Amphenol PCD

Engineering Change Request		ECR Number	R10442W
Initiator:	Aaron	Date:	2026.7.1
Part number description			
Reason of change: ☐ Customer requirement (list the feasibility analysis of customer specification: _____) ☐ Supplier request (list the PCR number: _____) ☒ internal improvement ☐ corrective ☐ other <u>Please describe here in detail:</u> Optimize the female pin assembly process by changing the construction from assembled type to integrated one-piece structure. The modification exerts no adverse impact on product assembly and electrical performance. (HVSL1200 Series)			
Change level and impact assessment (Please tick in the appropriate position)			
Change level	Change content	Whether to notify the customer	
Level 1	☐ Operator change	☐ It is not necessary to notify the customer for approval	
	☐ Correct the clerical errors of the drawing, BOM, etc., and this change will not affect the production process

Optimize the female pin assembly process by changing the construction from assembled type to integrated one piece structure. The modification exerts no adverse impact on product assembly and electrical performance. (HVSL1200 Series)

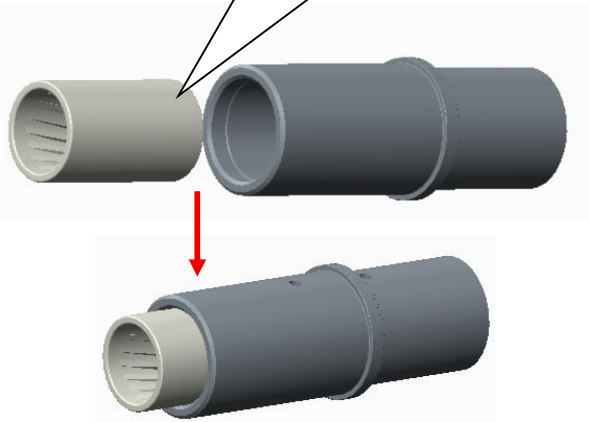
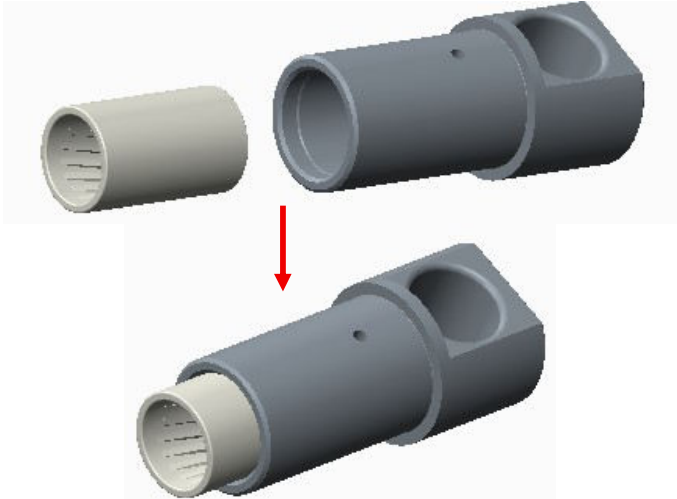
Before change Assembled type structure  		After change Monolithic construction  	
Disposition of old materials ☐ Rework ☒ Use as it is ☐ scrap ☐ Other (please describe): _____ ☐ N/A		Expect date to switch to new material 2026.7.30	
Approval by the supervisor of requester.: Chason Zhang		Approval by the head manager of the request dept.: Andy Gao	
Customer approval: ☐ Approved ☐ No approved ☐ Conditional approval (please describe) : Signature: _____ Date: _____			
Remark:
